STAFF REPORT

DATE: 4/13/2021
TO: Mayor & City Council
FROM: Joseph Dodson, Associate Planner
208-884-5533
SUBJECT: FP-2021-0009
Teakwood Place Final Plat

PLAT SHOWING
TEAKWOOD PLACE SUBDIVISION
LOCATED IN THE NW $\frac{1}{4}$ OF THE NW $\frac{1}{4}$ OF SECTION 29,
T.3N., R.1E., B.M., ADA COUNTY, IDAHO
2021

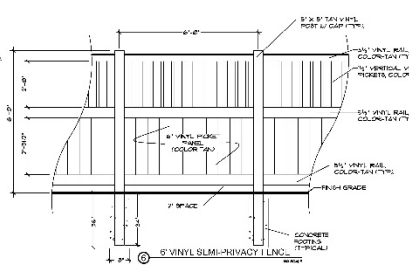
3. Prior to submittal for the City Engineer's signature, have the Certificate of Owners and the accompanying acknowledgement signed and notarized.
4. Prior to signature on the final plat by the City Engineer, the final plat prepared by Idaho Survey Group, LLC (Exhibit B), dated January 23, 2021, shall be revised as follows:

- a. Add a note stating: "This development is subject to the City of Meridian Development Agreement, Inst #2021-002167."
 - b. Add a note that Lot 3, Block 2 contains a pedestrian access easement along its northeast property line and include the recorded instrument number.

- c. Revise the street names on the plat per the Ada County Street Name Review response letter.
 - d. Add a note stating: The bottom of structural footing shall be set a minimum of 12-inches above the highest established normal ground water elevation.

- e. Add a note stating: Maintenance of any irrigation and/or drainage pipes or ditches crossing a lot is the responsibility of the lot owner unless such responsibility is assumed by an irrigation/drainage entity or lot owner's association.

- f. Revise Note #2 to name the appropriate irrigation district instead of "The City of Meridian."
5. Prior to signature on the final plat by the City Engineer, the landscape plan prepared by Leavitt & Associates Engineers, Inc. (Exhibit C), dated November 16, 2020, is approved as submitted.
